FIRE SAFETY INSPECTION REPORT

MAXCOM INTERNATIONAL, LTD.
37 HEMAYETPUR

ACCORD
on Fire and Building Safety in Bangladesh

April 7, 2014

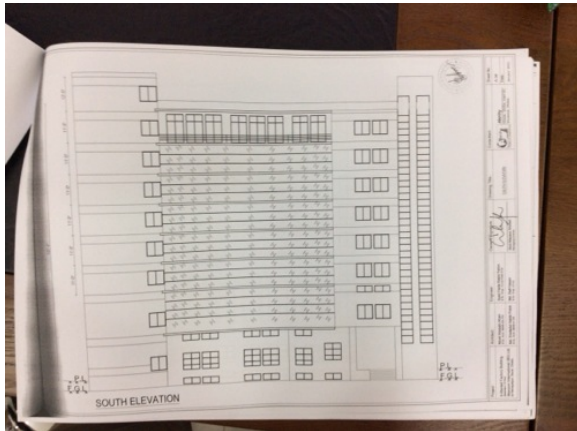
F-2	Fire Rated Construction	Areas used for combustible storage are not separated by fire-rated construction. Ground floor store room.	Provide dedicated storage rooms separated by minimum 1-hr fire-rated construction. Where separate storage rooms are not feasible, provide defined storage areas and limit the storage arrangement as follows: - Maximum height of 2.4m and maximum area of 23m² - If sprinkler protected: maximum height of 3.66m and maximum area of 93m² Separate areas of unenclosed combustible storage by a minimum clear distance of 3m.	Within 3 months
-----	-------------------------	---	--	-----------------
